ADDENDUM NO. 4

ATTLEBORO WATER DEPARTMENT

WADING RIVER WATER TREATMENT PLANT

CONTRACT NO. 10

ATTLEBORO WATER DEPT. ATTLEBORO, MA		WADING RIVER WATER TREATMENT PLANT	
PROCESS SECTION VIEWS VI		DESIGNED BY: RSP DRAWN BY: MUM/RSB	
DATE: 4/19/25		REVISION: 0	
SCALE: AS NOTED		T&H NO.: 6193 DATE: APRIL 2025	
TATA & HOWARD		20-D-9

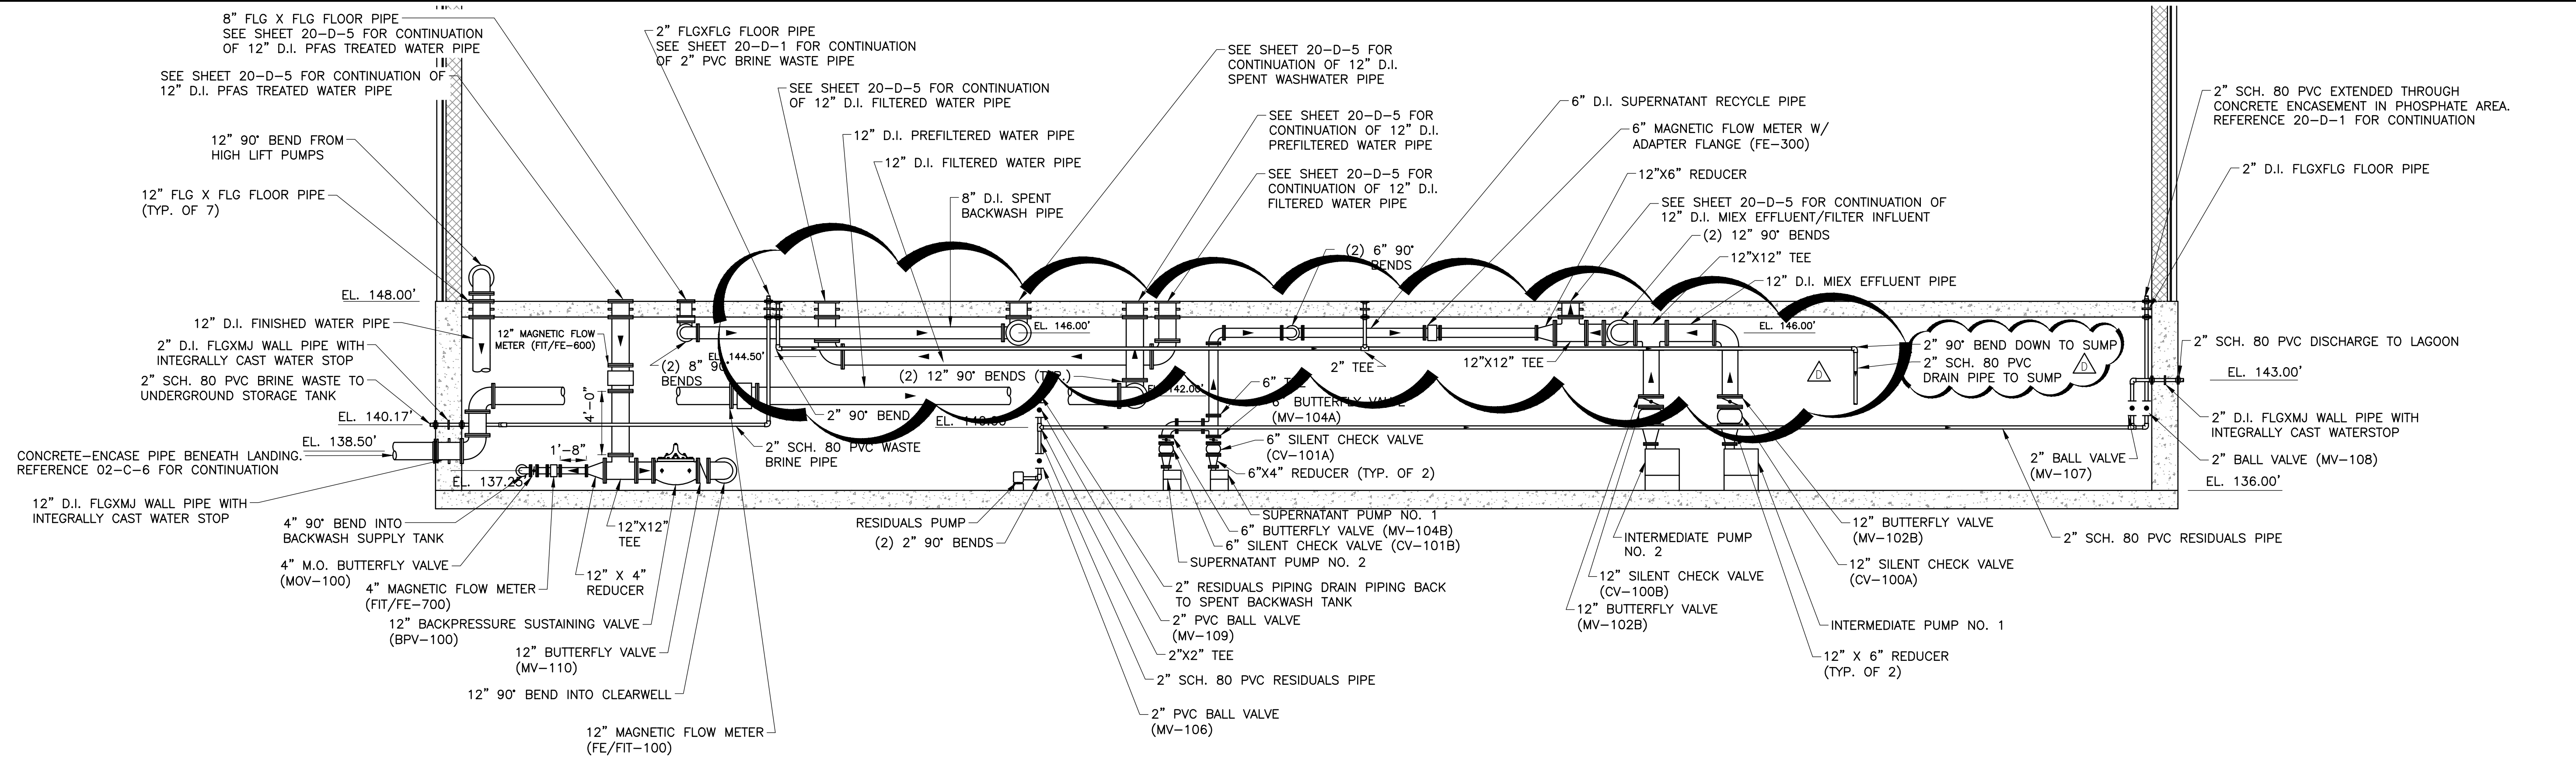
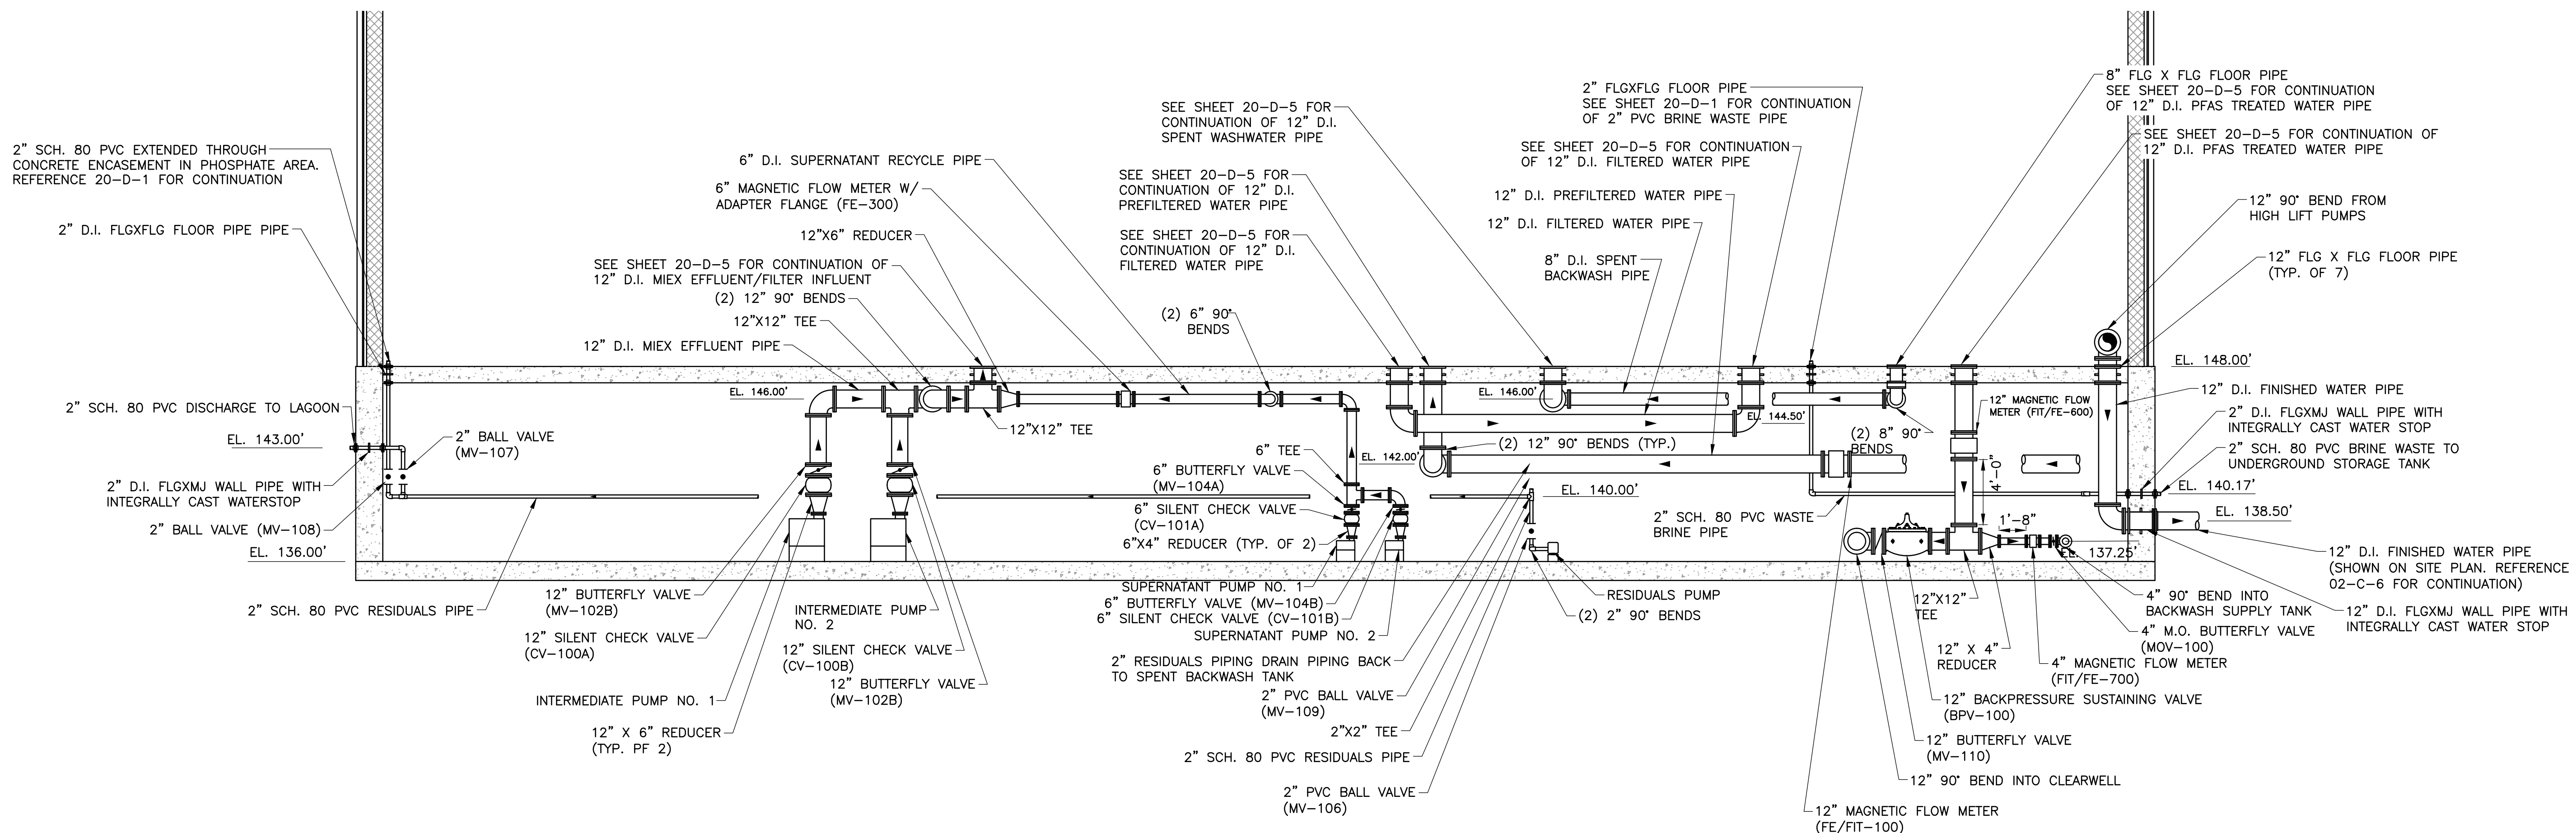
Delete and replace these drawings with attached revised 20-D-1, 20-D-2, 20-D-9 drawings. Revisions to noted drawings include four (4) 6-inch floor drains that drain down into the sumps in the pipe gallery via 2-inch Schedule 80 PVC Piping.
